MARKED-UP TECHNICAL SPECIFICATIONS PAGES FOR CATAWBA

DESCRIPTION OF PROPOSED CHANGES AND TECHNICAL JUSTIFICATION

TS 3.8.4 governs DC source requirements for Modes 1, 2, 3, and 4. In particular, SR 3.8.4.8 delineates requirements for the performance of the battery service test. This test is performed on an 18-month frequency. SR 3.8.4.9 delineates requirements for the performance of the performance discharge test or modified performance discharge test. This test is normally performed on a 60-month frequency, although the surveillance interval is reduced in the event that battery degradation exists or the battery has reached 85% of its expected life. SR 3.8.4.8 and SR 3.8.4.9 each require its respective test to be performed during unit shutdown conditions for the DC channel batteries. This is achieved via notes to the SRs which state that the surveillance shall not be performed in Mode 1, 2, 3, or 4.

Figure 1: Alignment of
Channel A During
Normal Operation

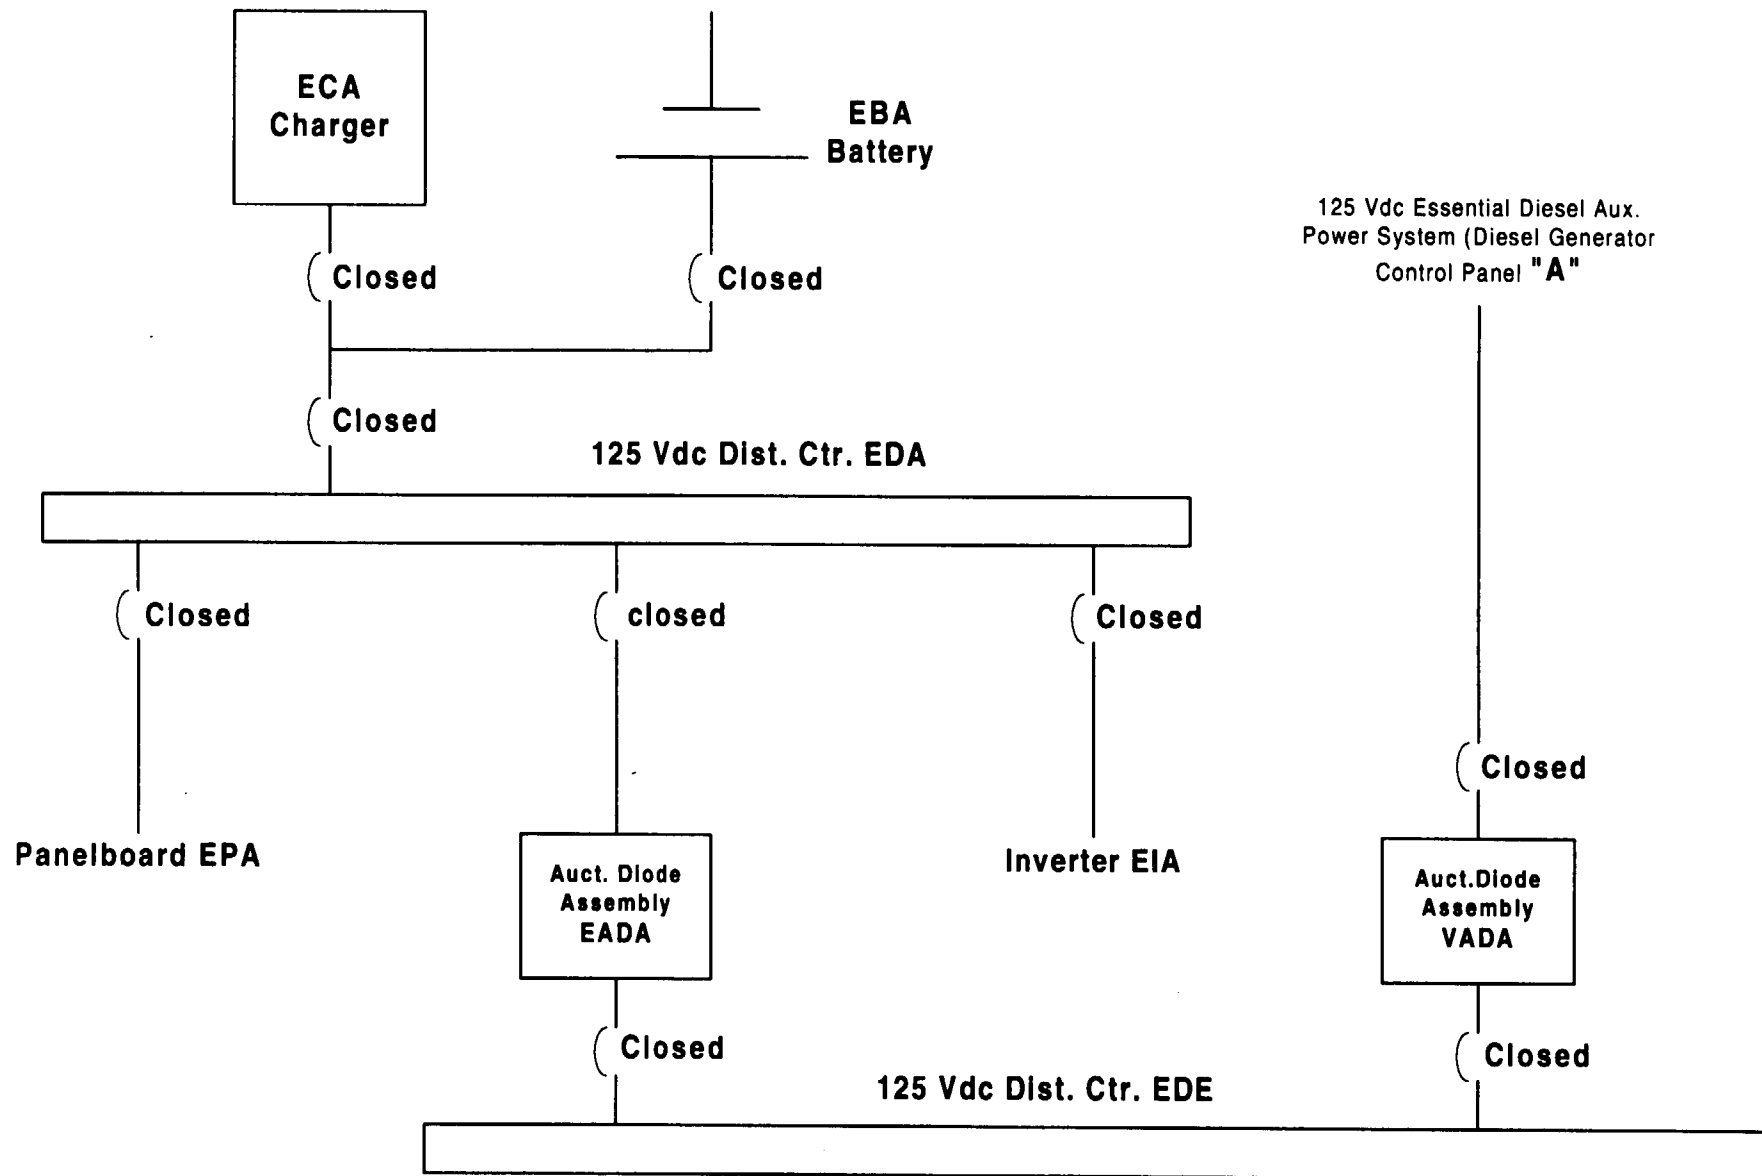
source. Refer to attached Figure 1 for a schematic representation of the normal system alignment for channel A, which is representative of all four channels, with the exception that channels B and C do not have the auctioneering diode assemblies' loads.

Figure 2: Alignment of
Channels A & C During
EBA Out of Service

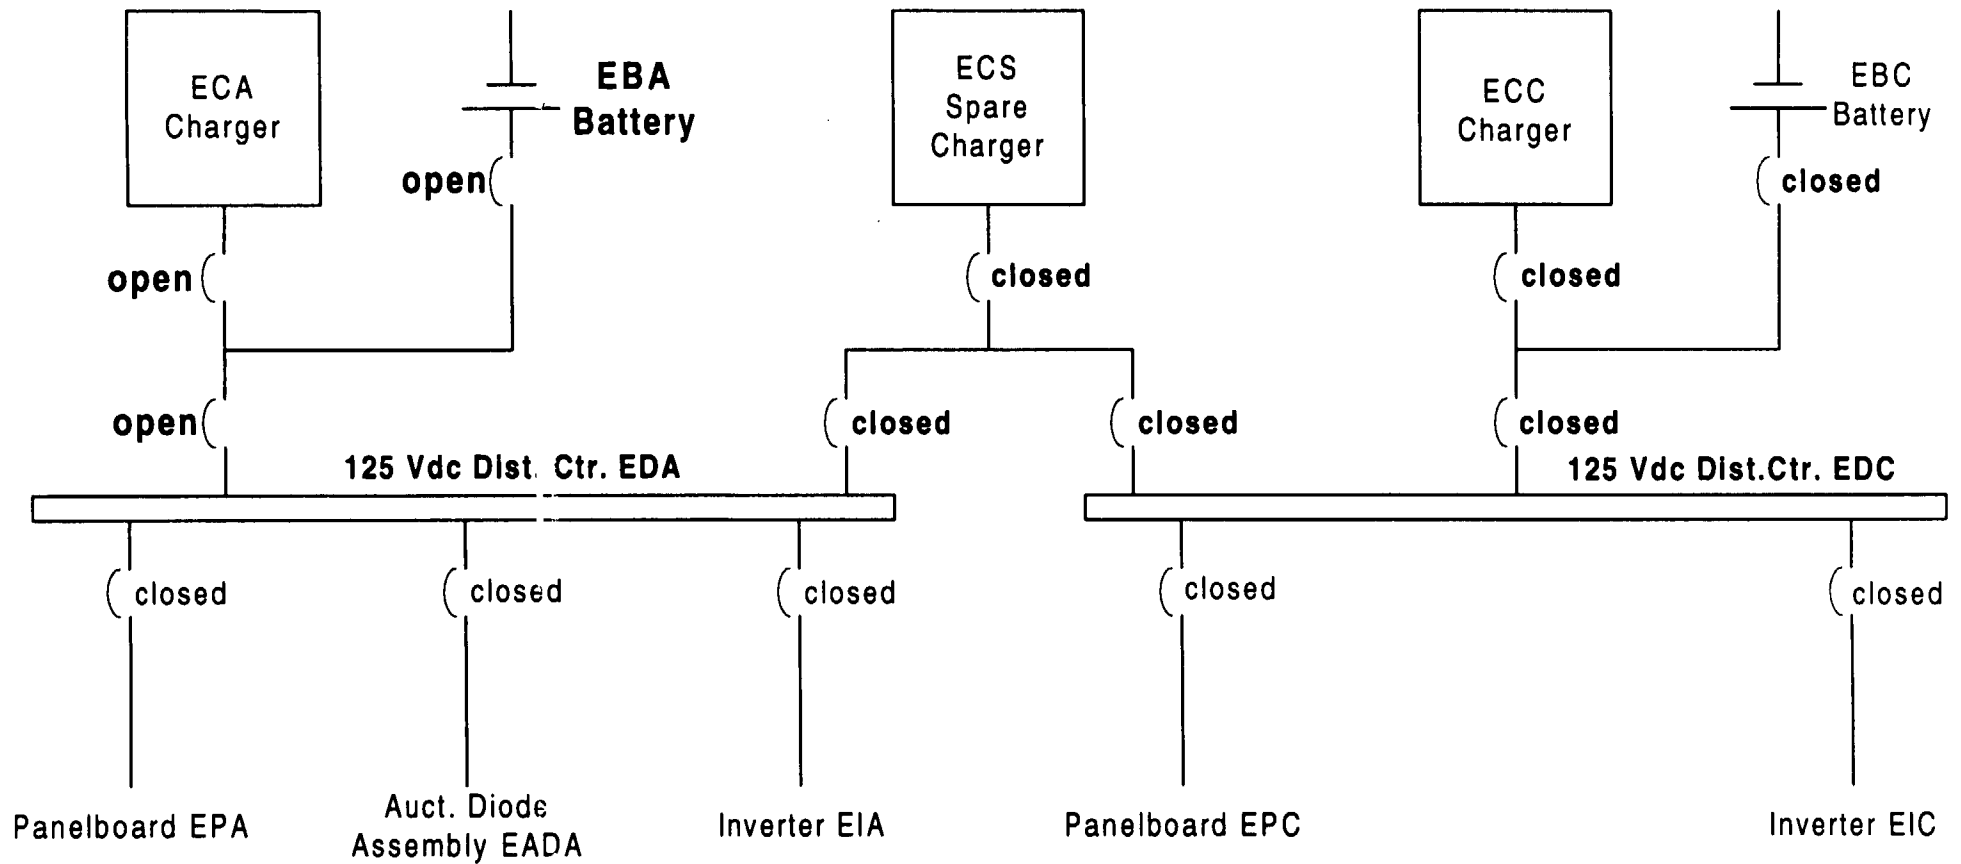
related load channel for two hours. For example, battery EBA is sized to simultaneously supply the design basis accident loads fed from distribution center EDA, auctioneering diode assembly EADA, and distribution center EDC. Refer to attached Figure 2.

As an example, if a test is being conducted on battery EBA, channel A would first be declared inoperable. Channel A would then be tied to battery-backed channel C. Channels B and D would be unaffected during the conduct of the test. Therefore, both safety trains would still be capable of performing their required functions during an accident, since each battery has the ability to supply two load channels for a two-hour period during a design basis accident. Figure 2 illustrates the alignment of channels A and C during battery EBA testing.
